CITY OF ALBUQUERQUE

Re: O'Reilly Auto Parts, 8001 Venture St. NE
Traffic Circulation Layout – Not Required
Engineer's Stamp dated 04-13-18 (D20-D010C)

Project Number 2017010
Drawn By OW
Checked JW
Issue Date April 13, 2018
Site Plan for Building Permit

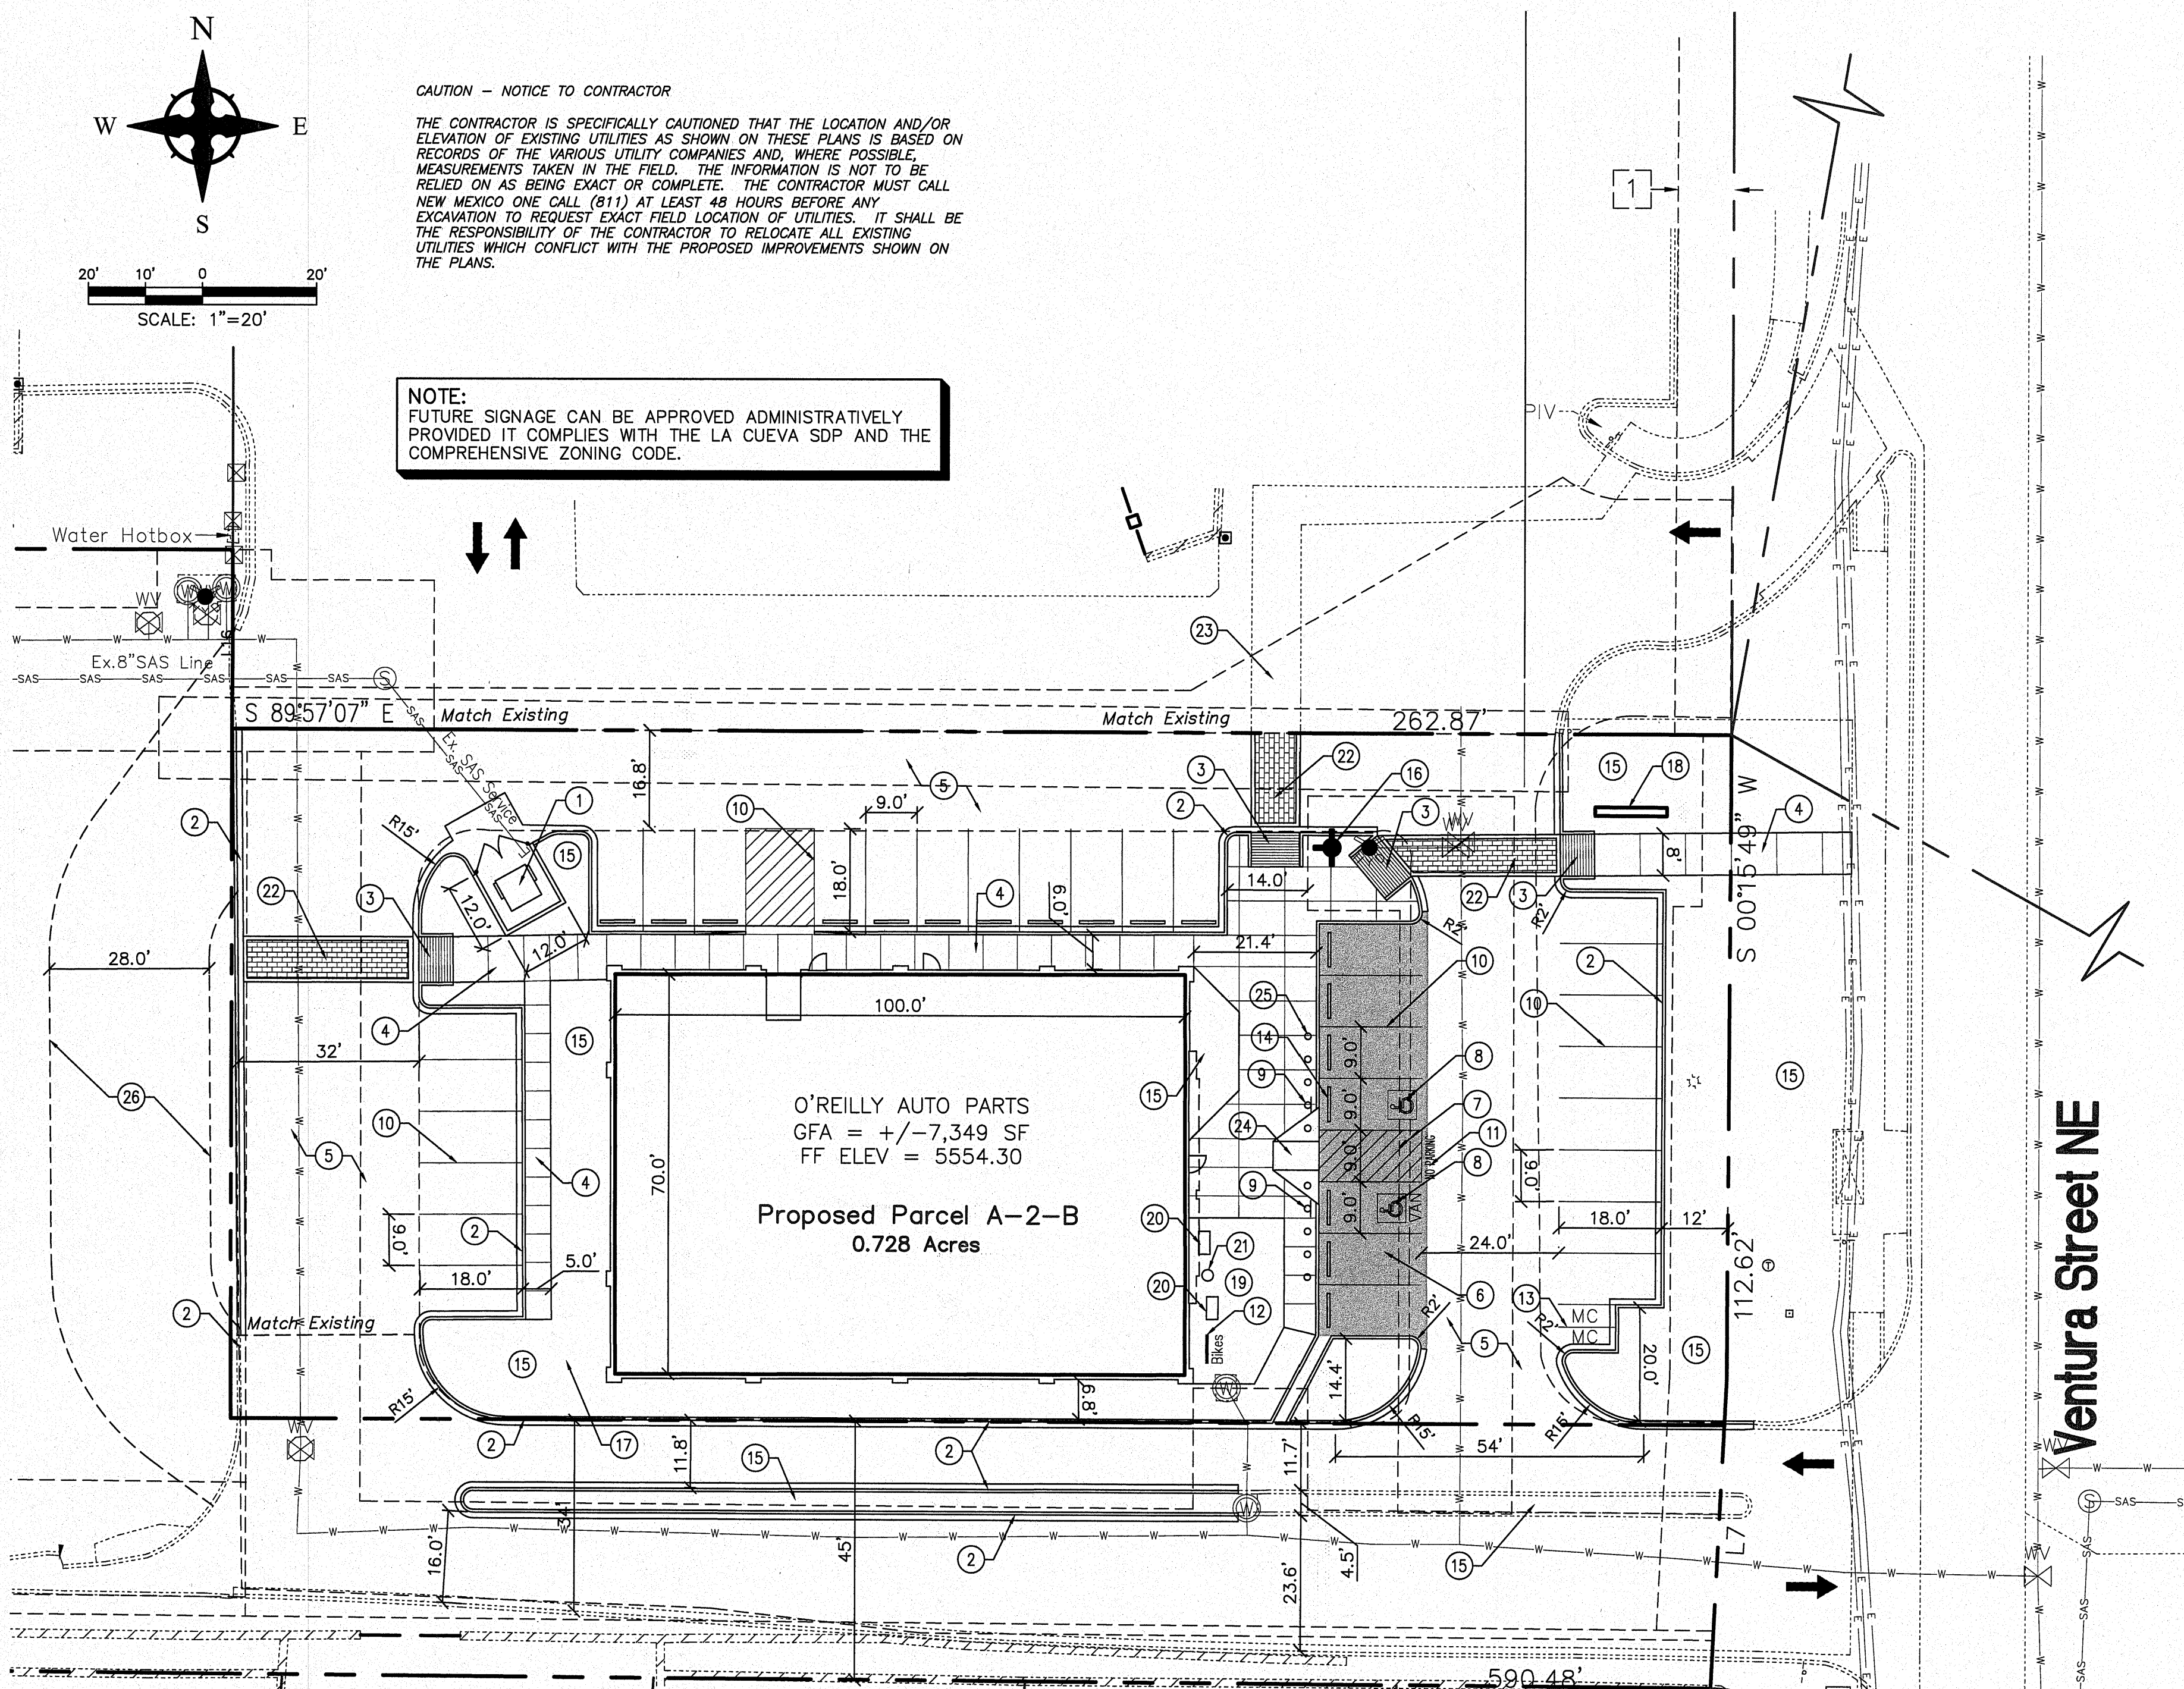
Thank you for the TCL submittal received 05-01-18. The above referenced plan is not required to go through the TCL process. Due to the existing zoning, this project is site plan controlled and will need to be submitted through the appropriate Board, (EPC, DRB, and AA) for approval. Verify with the Zoning Department for the correct Board approval. If this plan has already been approved by one of the Boards, be sure to include it in the plan set when applying for building permit.
